# Access Compliance Report

## Public Rights-of-Way

### (Curb Ramps)

Intersection ID: 12285	Main Street: E_TRADE_ST	Cross Street: N_TRYON_ST	Location: S
ADA ID: 0349B768C324	Ramp Type: Perp	Initial Pass/Fail: Fail	Overall Compliance: No
Severity Score: 13.75			
Codes/Mitigation Info/Possible Solution		Field Measurements/Component Compliance

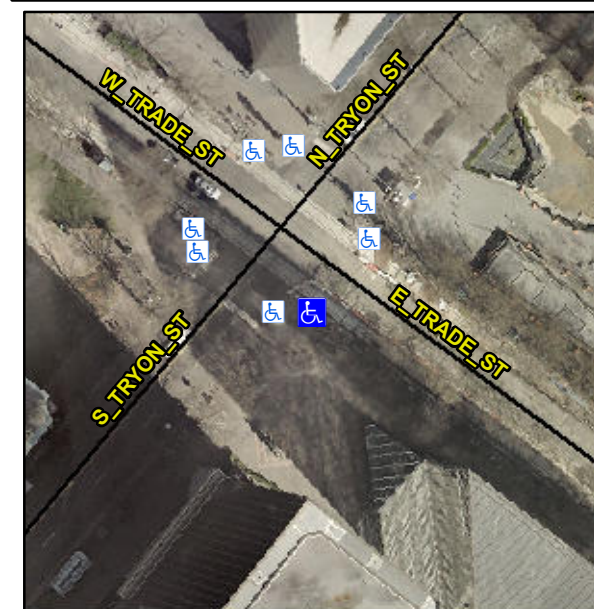
**R304.2.2**

Compliance	Description	Data	Compliance	Description	Data
N/A	Ramp Length (in)	23.5	No	Ramp Slope (%)	9.2
Yes	Ramp Width (in)	48.0	Yes	Ramp XSlope (%)	3.4
N/A	Flare Type LT	N/A	N/A	Flare Type RT	N/A
N/A	Flare Slope LT (%)	N/A	N/A	Flare Slope RT (%)	N/A
N/A	Flare Traversable LT?	N/A	N/A	Flare Traversable RT?	N/A
N/A	Landing Length (in)	N/A	N/A	DWS Provided?	N/A
N/A	Landing Width (in)	N/A	N/A	DWS Contrast?	N/A
N/A	Landing Slope (%)	N/A	N/A	DWS Length (in)	N/A
N/A	Landing X Slope (%)	N/A	N/A	DWS Full Width?	N/A
N/A	Landing Curb? (Y/N)	N/A	N/A	DWS Offset (in)	N/A
N/A	Shared Landing?	N/A			
N/A	Gutter Ponding?	N/A	N/A	Gutter Slope (%)	N/A
N/A	Gutter Lip Ht (in)	N/A	N/A	Gutter X Slope (%)	N/A
N/A	Painted X Walk1?	Yes	N/A	Painted X Walk2?	N/A
	X Walk 1 Direction	To NE		X Walk 2 Direction	N/A
N/A	X Walk 1 Width (in)	160.0	N/A	X Walk 2 Width (in)	N/A
	X Walk 1 Slope (%)	0.7		X Walk 2 Slope (%)	N/A
	X Walk 1 X Slope (%)	6.2		X Walk 2 X Slope (%)	N/A

**Remove & Replace Entire Ramp.**
